**Project: 2023 Emergency Culvert Repair Project**

**Item: Addendum #1**

This addendum shows a revised bid schedule, clarification of the type of pipe for the culvert and CB storm pipe.

**5TH STREET EMERGENCY CULVERT REPAIR**

**SCHEMATIC CULVERT REPLACEMENT PLAN**

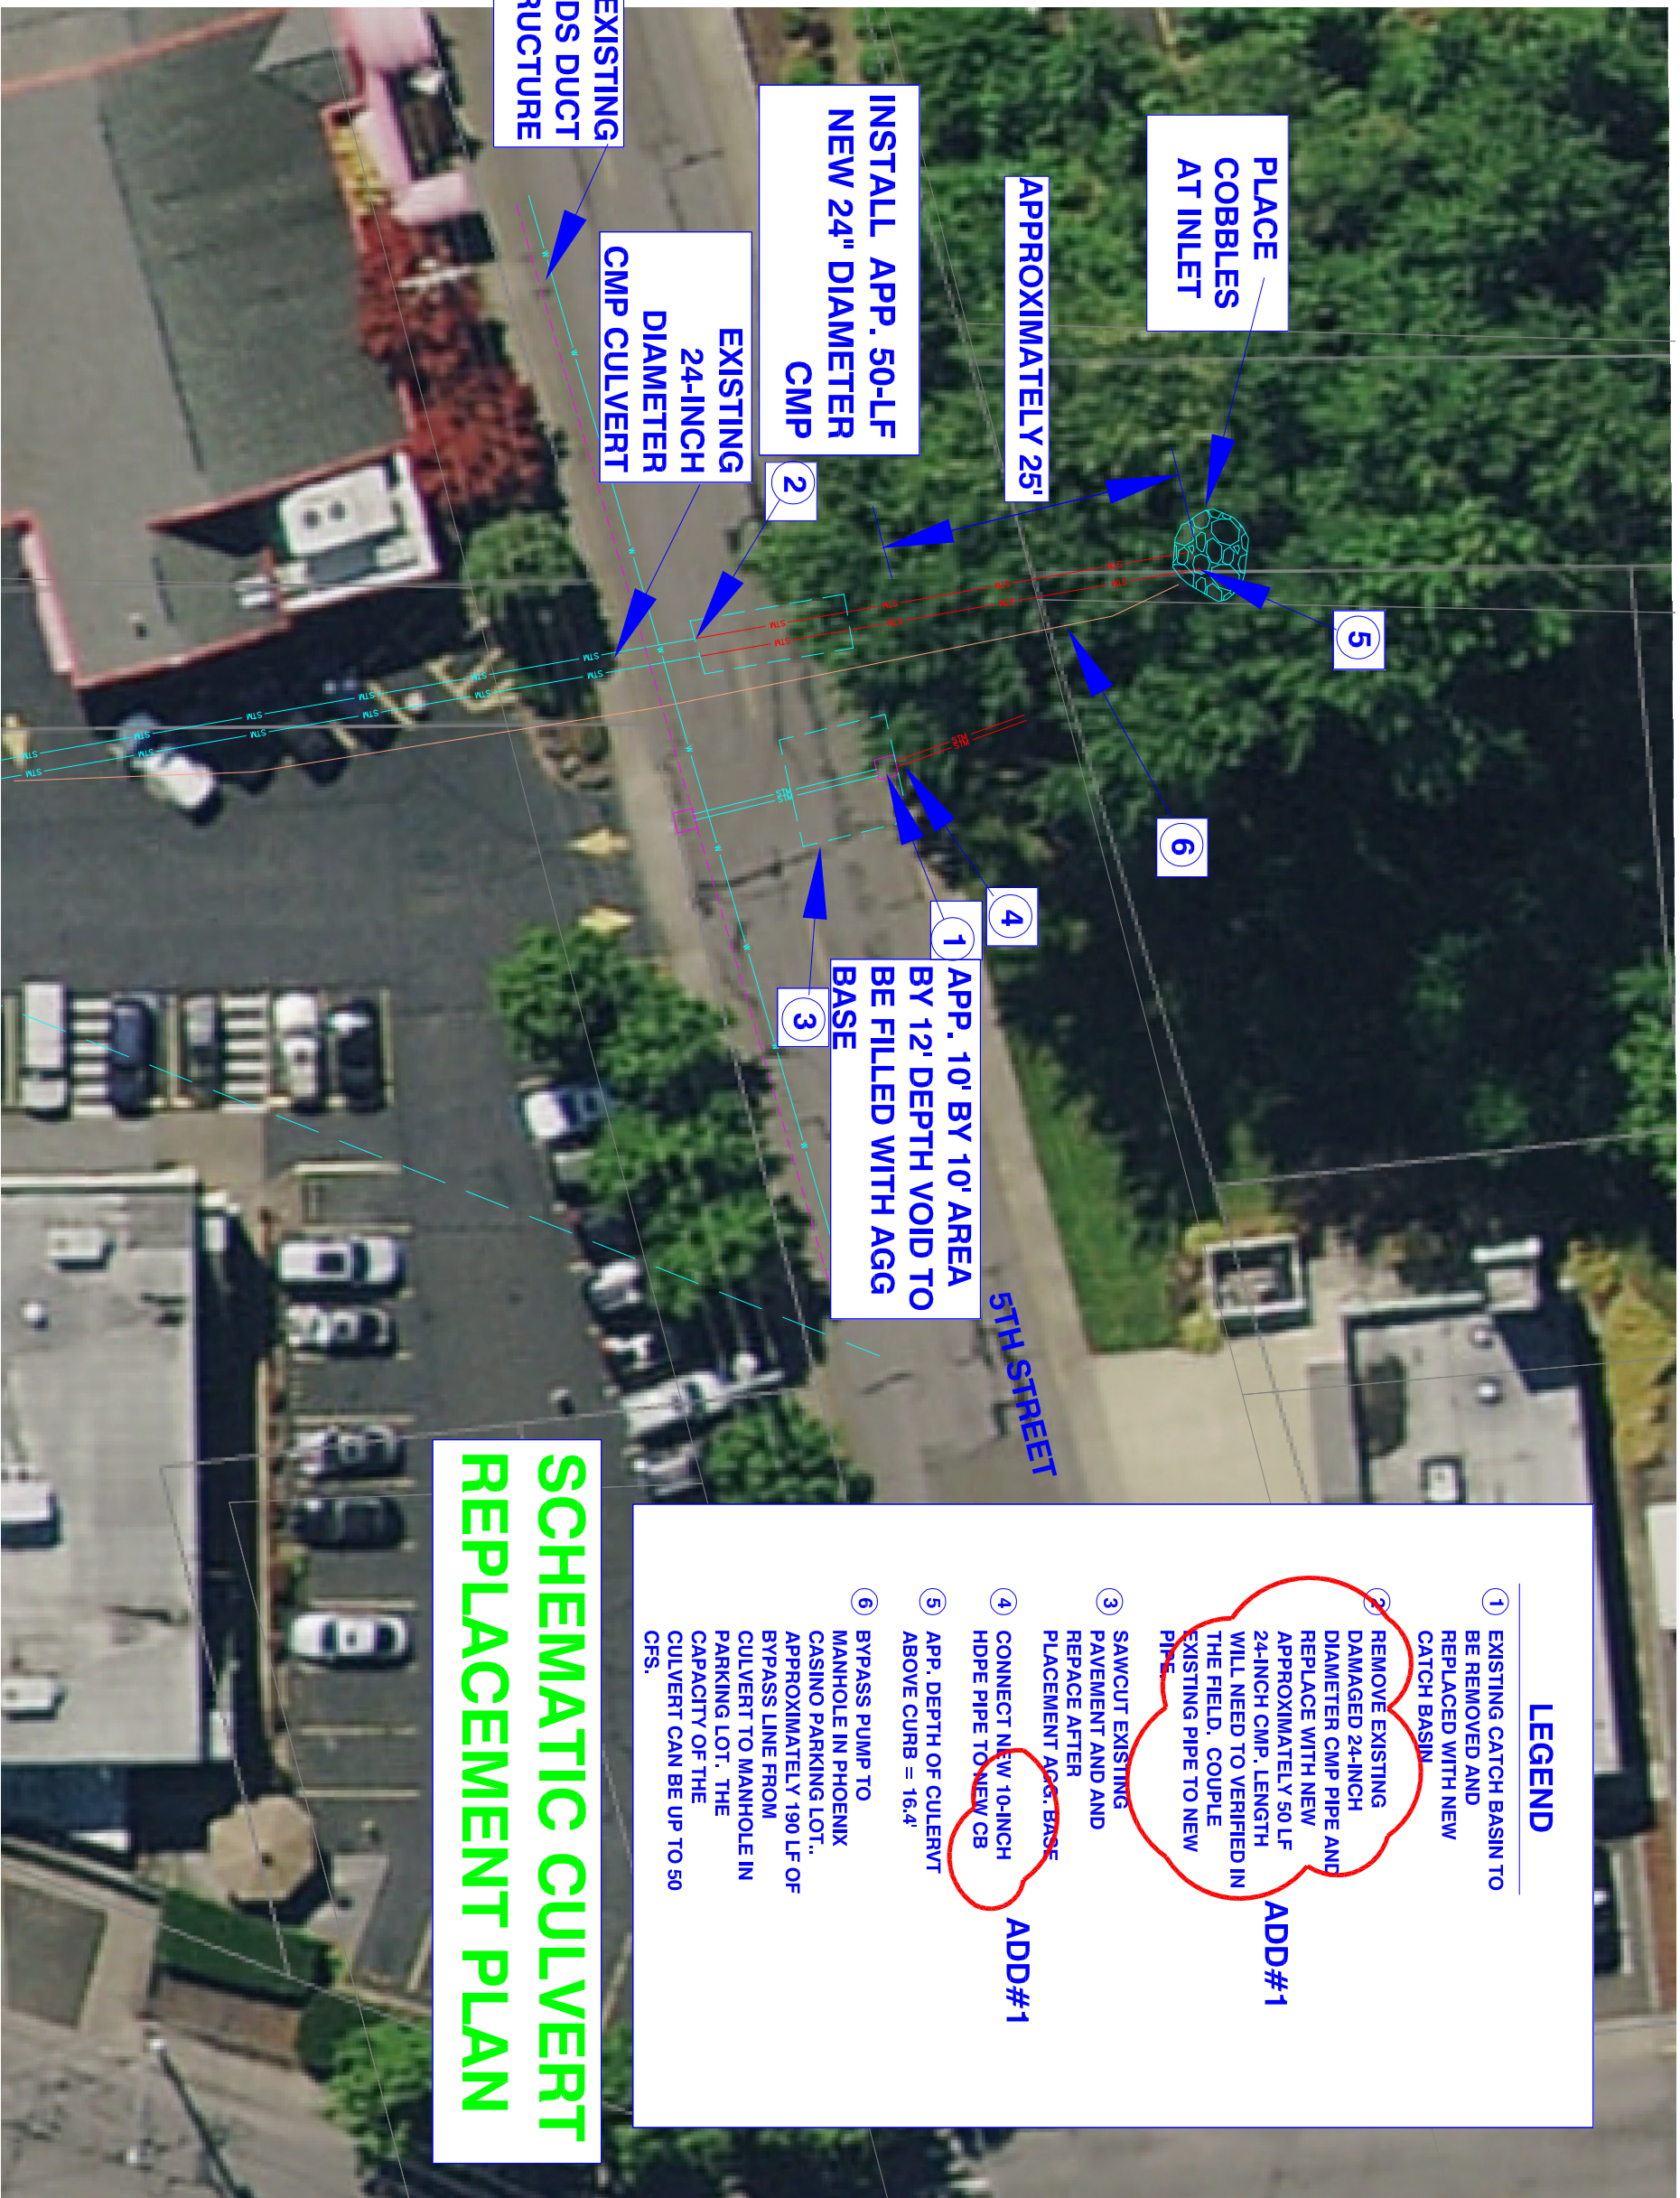
- 1 EXISTING CATCH BASIN TO BE REMOVED AND REPLACED WITH NEW CATCH BASIN
- 2 REMOVE EXISTING DAMAGED 24-INCH DIAMETER CMP PIPE AND REPLACE WITH NEW APPROXIMATELY 50 LF 24-INCH CMP. LENGTH WILL NEED TO VERIFIED IN THE FIELD. COUPLE EXISTING PIPE TO NEW PIPE
- 3 SAWCUT EXISTING PAVEMENT AND AND REPLACE AFTER PLACEMENT AGG. BASE
- 4 CONNECT NEW 10-INCH HDPE PIPE TO NEW CB
- 5 APP. DEPTH OF CULVERT ABOVE CURB = 16.4'
- 6 BYPASS PUMP TO MANHOLE IN PHOENIX CASINO PARKING LOT.. APPROXIMATELY 190 LF OF BYPASS LINE FROM CULVERT TO MANHOLE IN PARKING LOT. THE CAPACITY OF THE CULVERT CAN BE UP TO 50 CFS.

**ADD#1**
